CITY OF PANAMA CITY BEACH
September 1, 2023

ADDENDUM NO. 2

**PCB23-48 ITB
FIRE STATION #32**

This addendum modifies Fire Station #32 Bid Documents dated August 1, 2023

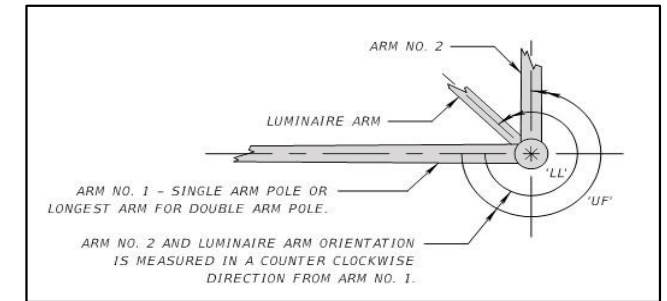
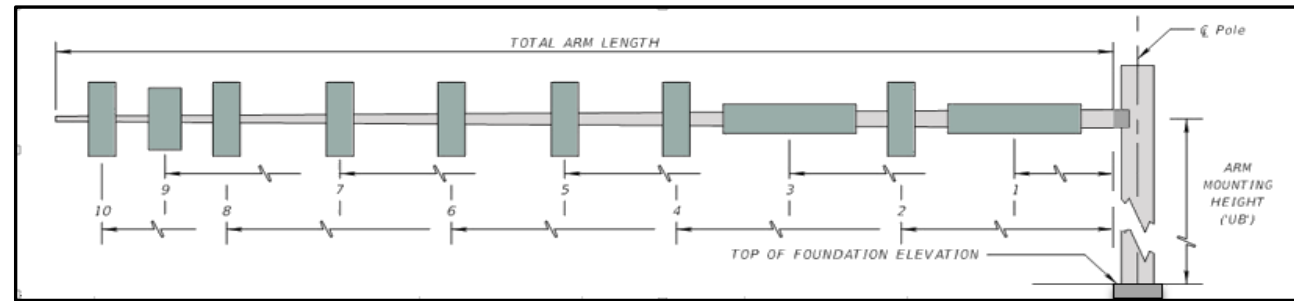
13. Please provide the drilled shaft data table which shows the dimensions of each shaft along with the soil borings that would be for each location.

Standard Mast Arm data tables are provided (see attachments 1 and 2) and are hereby incorporated into FDOT ROW IMPROVEMENT PLANS.

Soil borings at shaft locations are not available – Reference Subsurface Exploration and Geotechnical Evaluation report for general site soils data.
